## Smart City Ahmedabad Development Limited

# Corrigendum 5

**Tender No:** 1 Smart City Ahmedabad Development Ltd (SCADL) 241853

241853- Notice Inviting RFP for Selection of Implementation Agency for Supply, Installation, Commissioning and operation & maintenance of Pan city ICT Infrastructure and Integrated Command and Control Center for Smart City Ahmedabad (Gujarat) – Smart city Ahmedabad Development Ltd(SCADL)

**Annexure 1: Layouts - AMC CCC & DC, Police TCC & DC**

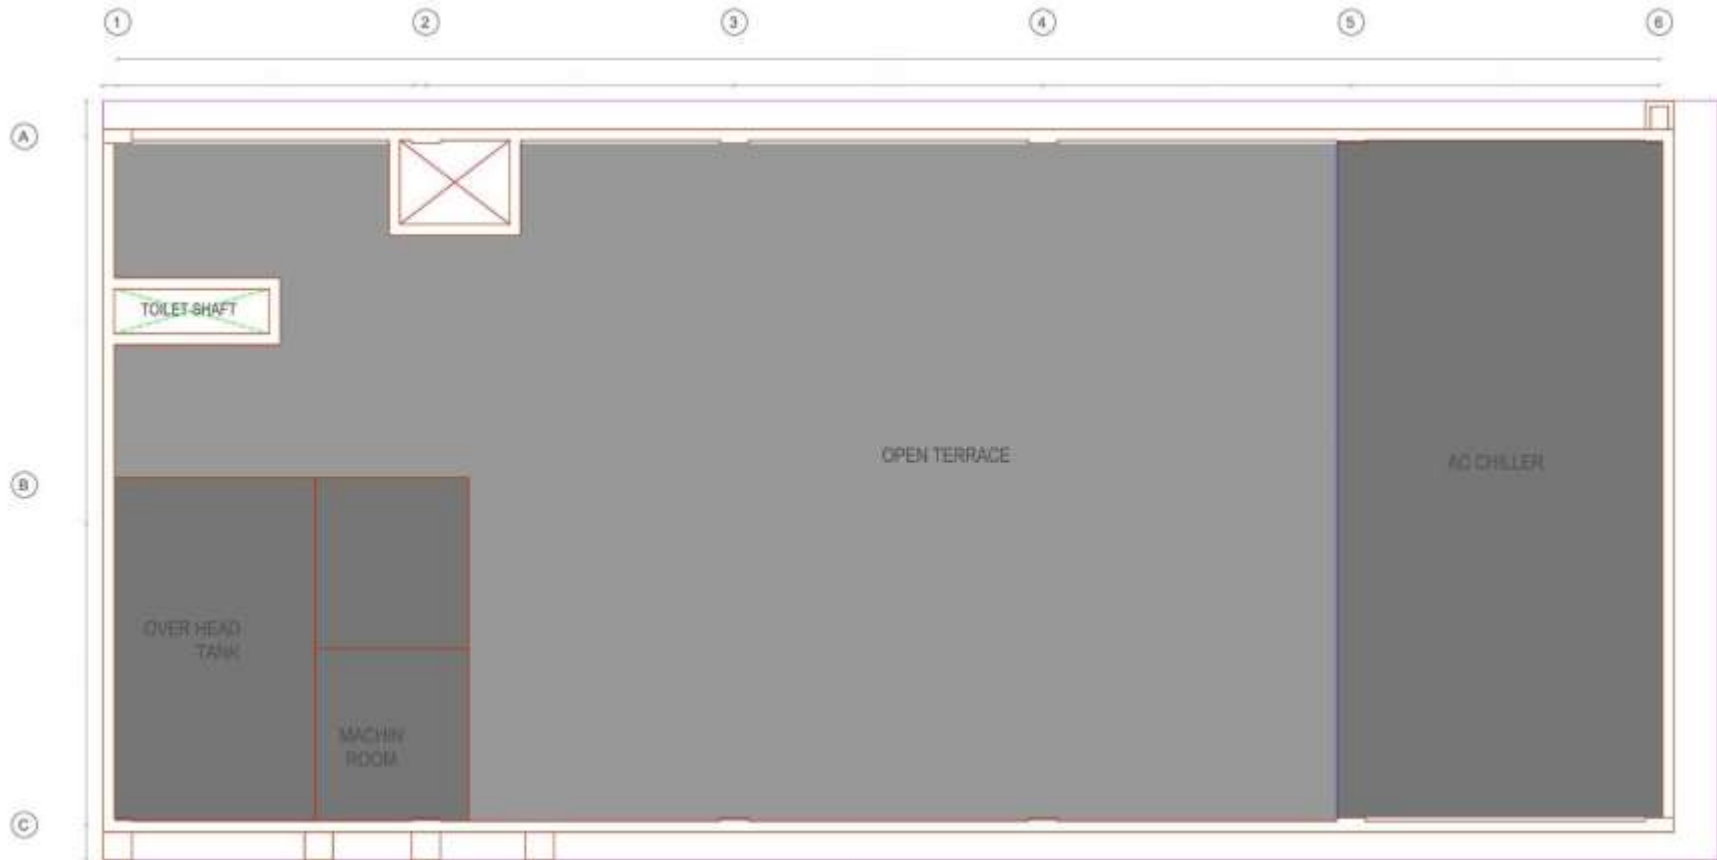
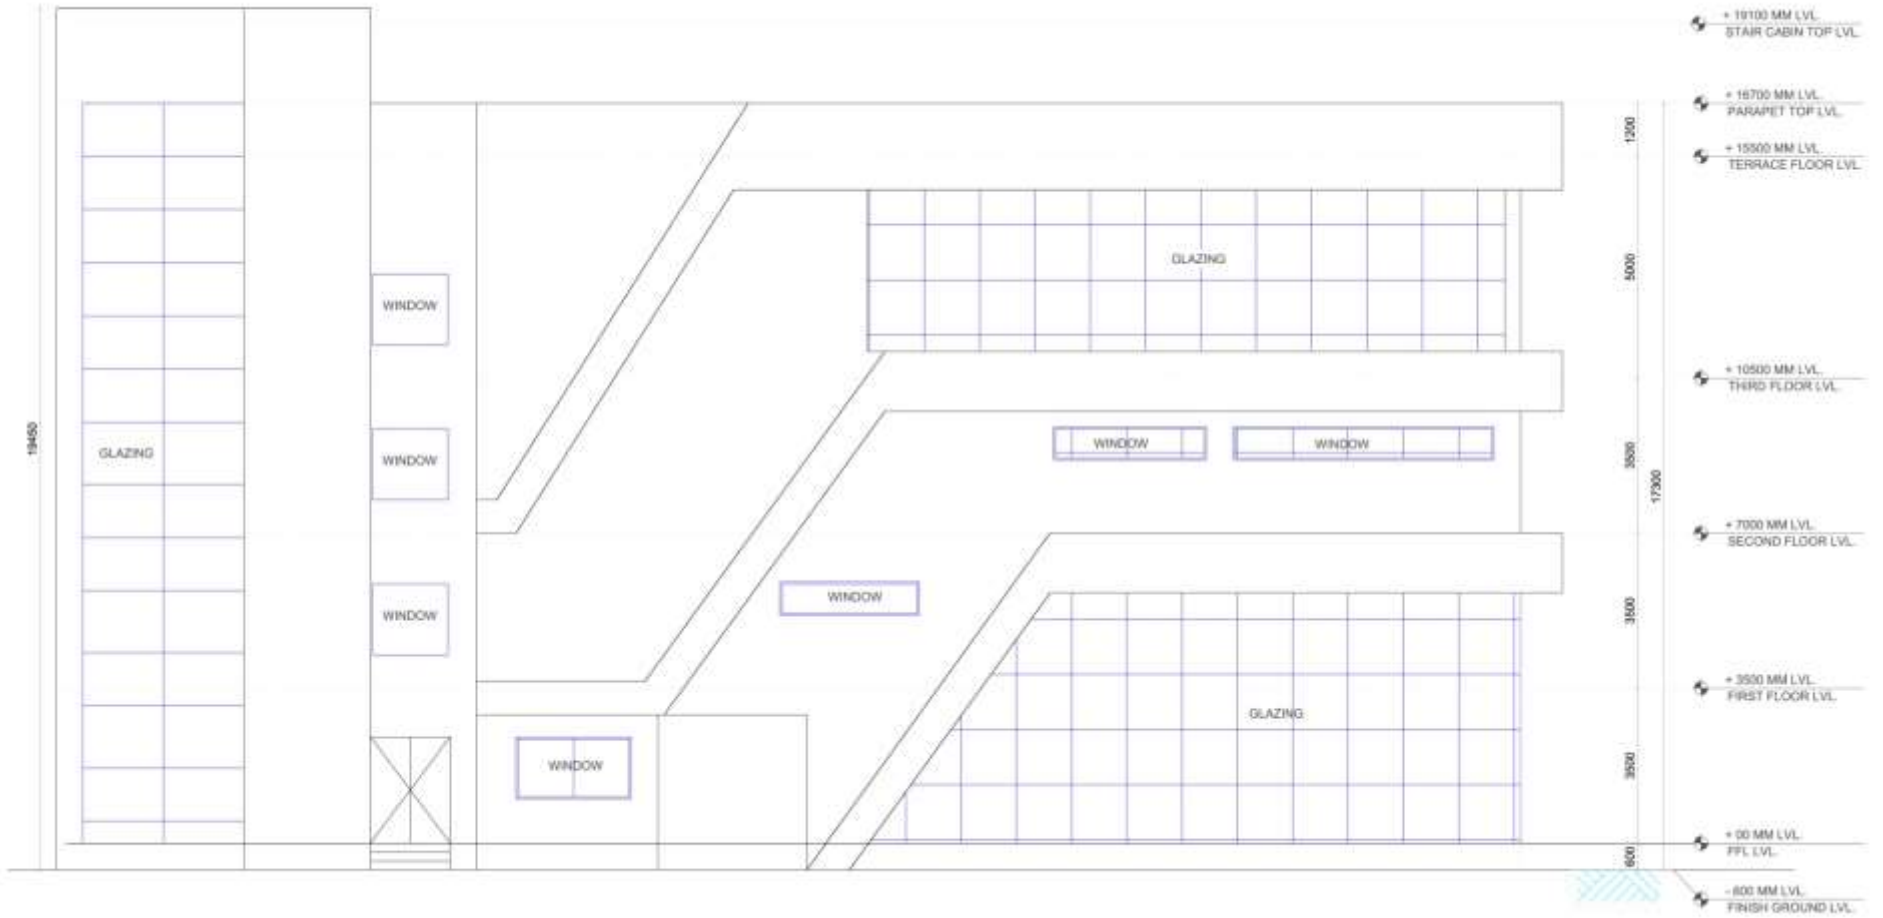
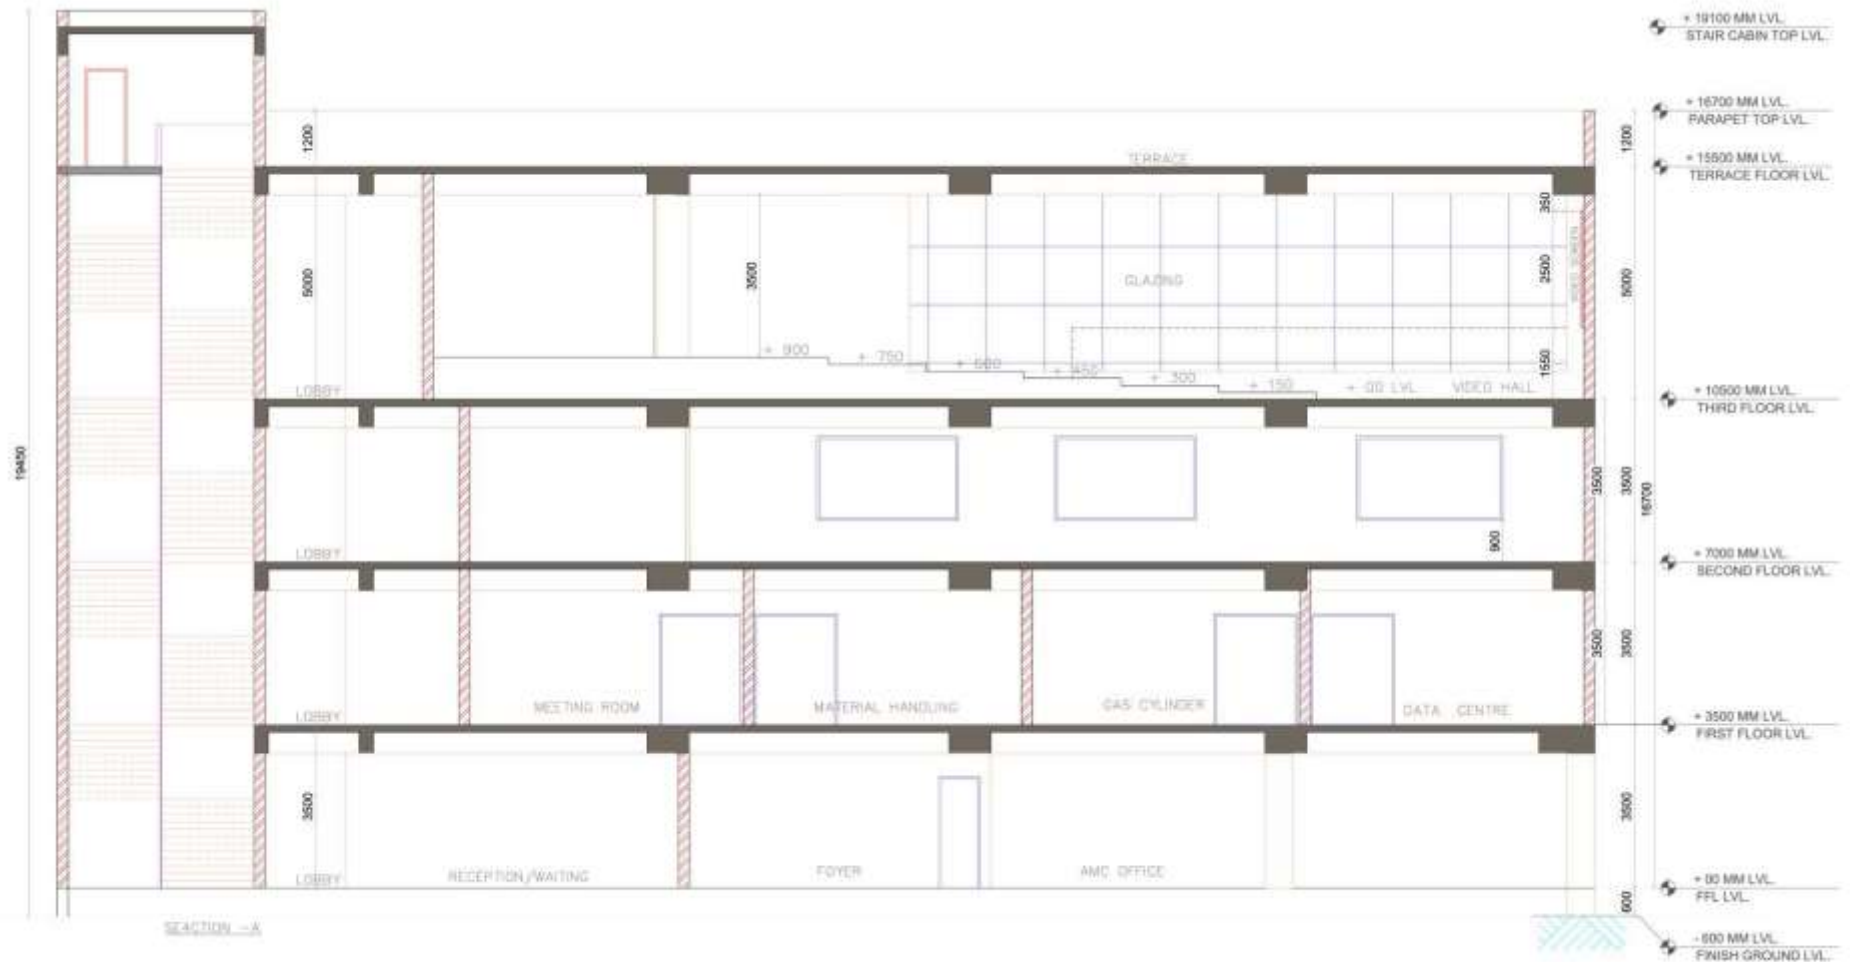
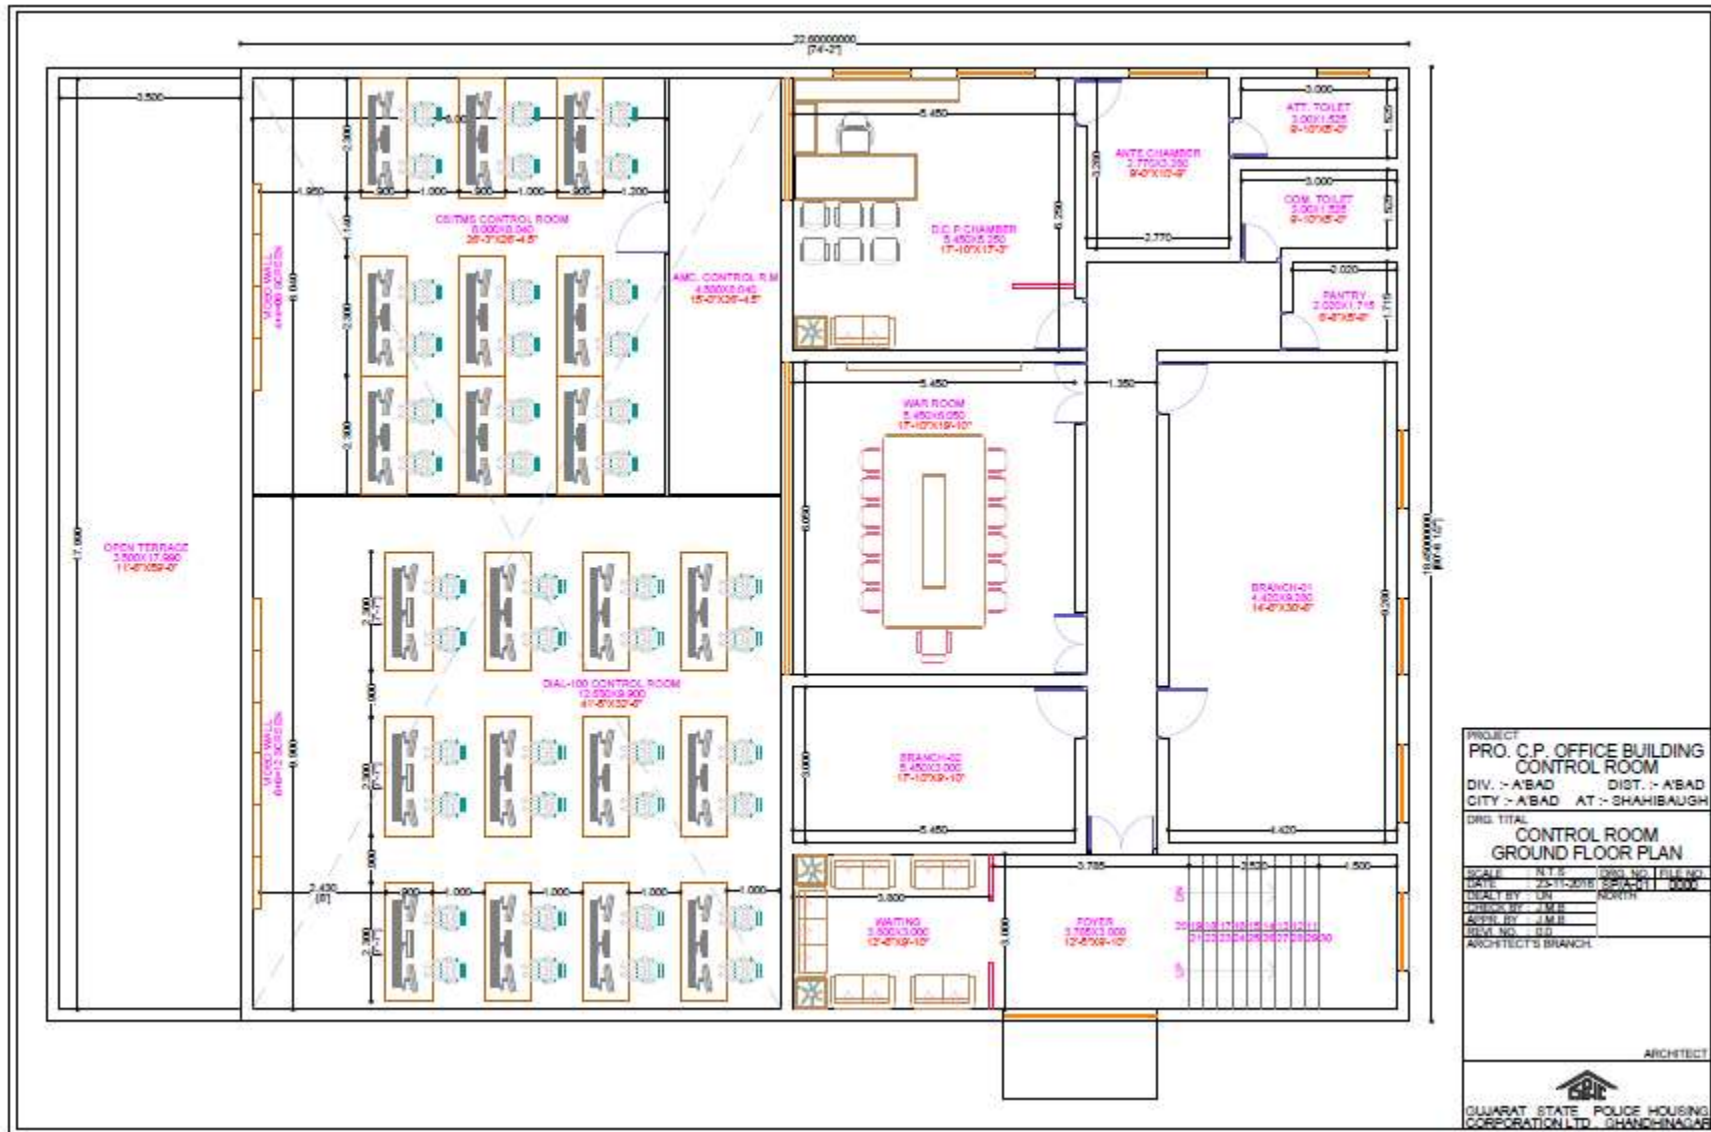
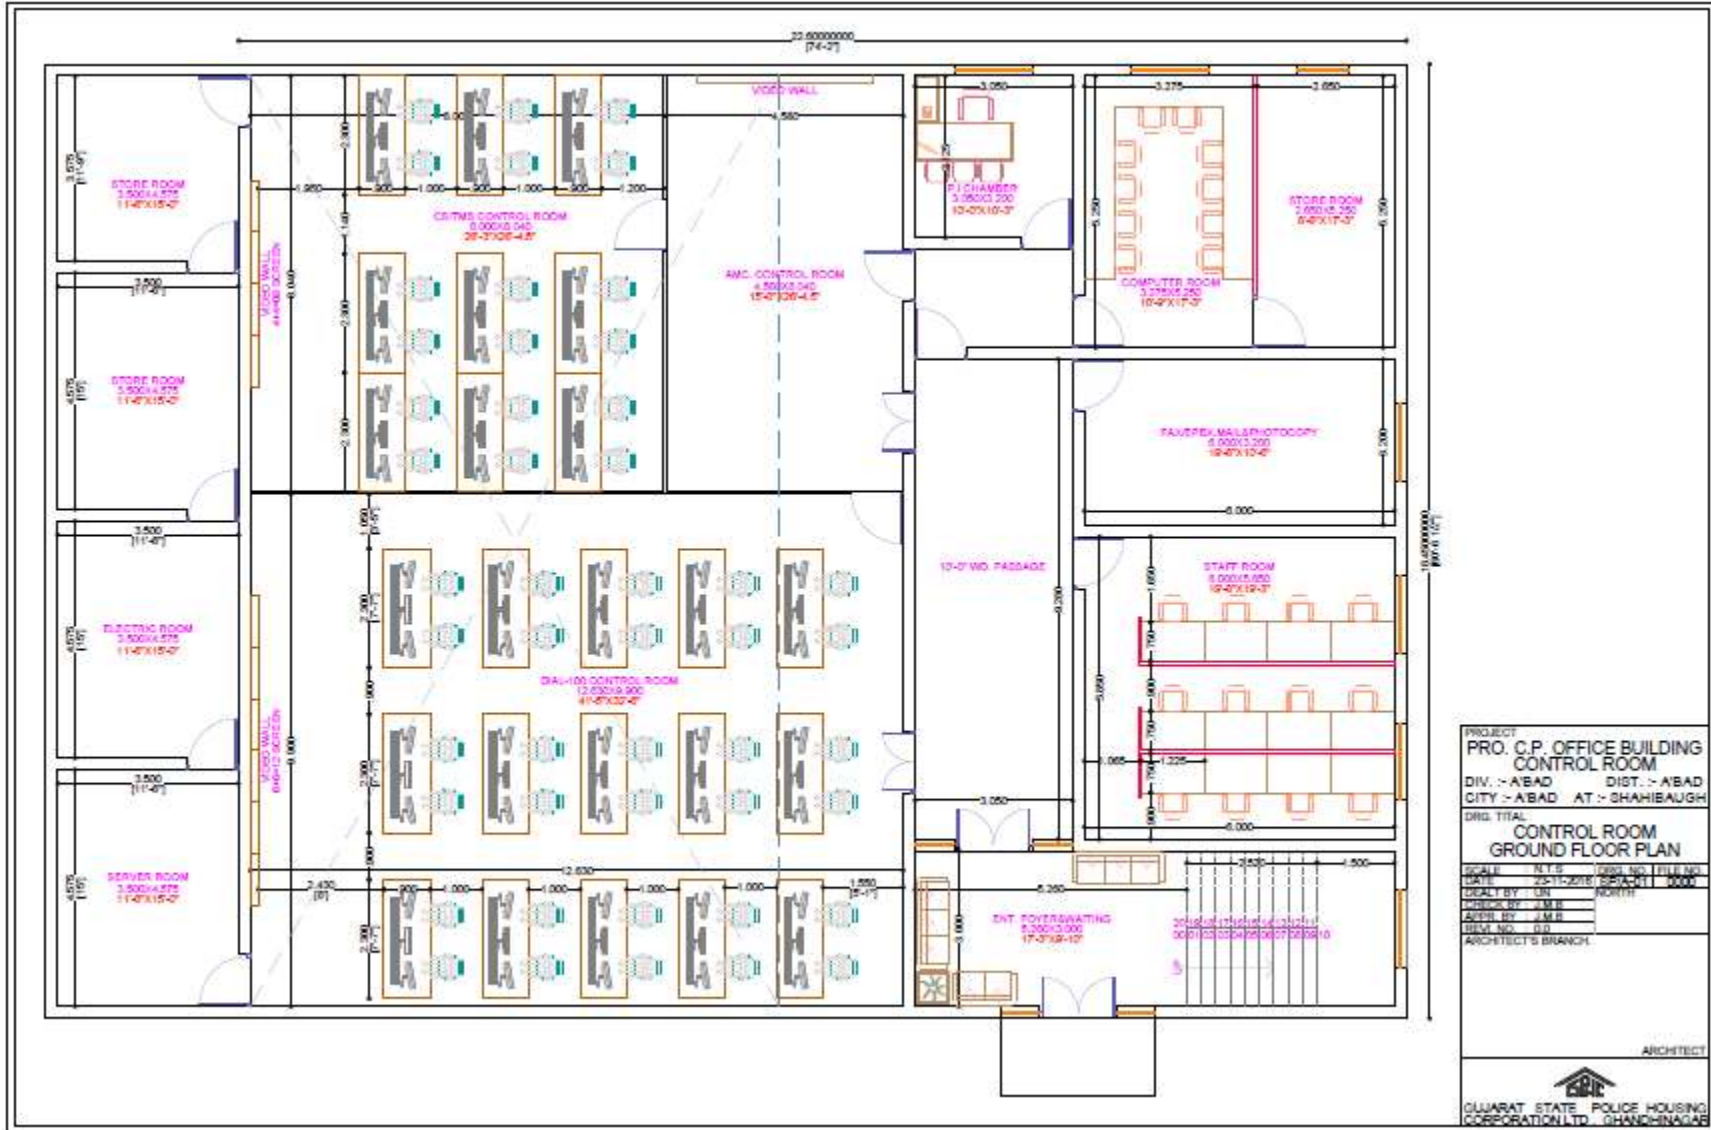
#	Reference Sections	Content in the RFP requiring clarification	Queries	Response to Queries
28	Financial Bid, Schedule I	Location for CCC and DC's	Where does Command Control Center and Data Center cum Surveillance Area are placed? What is the distance between these 2 Areas?	For AMC there is a CCC and DC which will be in the same premise at Paldi, while for Police, there is a TCC and DC which will be in the same premise at CP Office
29	Financial Bid, Schedule I	Location details	Where does the Rooms (Operator main area, Wireless Channel Operator Room, War room, Computer control room/IT Cell, Dining area, Police Inspector room, DCP Control Room) mentioned in SCHEDULE – I (For Request Order 2) Table belongs to? Please clarify.	These rooms are for the Traffic Control Room (TCC) i.e. the Police Department, Ahmedabad. For further Clarity please refer the Price Bid Document
30	Financial Bid, Schedule I	Layout for BMS Equipments	Layout is required to arrived the actual detailed Quantities from highlevel BOM given for Fire Alarm System, Access Control System, Public Address System(PAS), Water Leakage Detection(if required), Rodent repellent(if required), etc. Please provide the same.	Please refer to Corrigendum 5, Annexure 1 for detailed layout of CCC, DC , TCC and DC

#	Reference Sections	Content in the RFP requiring clarification	Queries	Response to Queries
			Public Address Systems? Please clarify.	
33	Financial Bid, Schedule I, Fire Extinguisher	Fire extinguishers- 4 Kg Dry Powder/Co2 based Fire Extinguisher (With Installation and 5 Year O&M Support) --- Nos. 25.	We understand 5 year O&M Support as, 1 year warranty and 4 years AMC Support. Please check & confirm.	As per Corrigendum 2, The requirement is for 5 years Operations and Maintenance which includes 5 years warranty & support
34	General	<b>Building Management System</b> : Solution should provide a pre-integrated, centralized and consolidated platform for end to end management of the building, which would include: Air-conditioning units, D.G. sets, HT Panel, LT panel, UPS Systems, Fire Alarm system, Surveillance System, Access Control, Water leakage detection, Rodent repellent, Temperature and Humidity, Fire, etc.	Here BMS integration asked for Water Leakage Detection (WLD) & Rodent repellent systems (RRS) as well, whereas these systems are not factored in Price Bid/BOM. How to factor the same? Please clarify. Whether WLD & RRS are required for CCC and DC Areas? If Yes, Please share the floor layout in Autocad / PDF format with Room dimensions & false ceiling, false flooring breakup details for every room to Design & arrive the Actual Bill of Materials for given Layout.	Please refer to Corrigendum 5, Annexure 1 for detailed layout of CCC, DC , TCC and DC
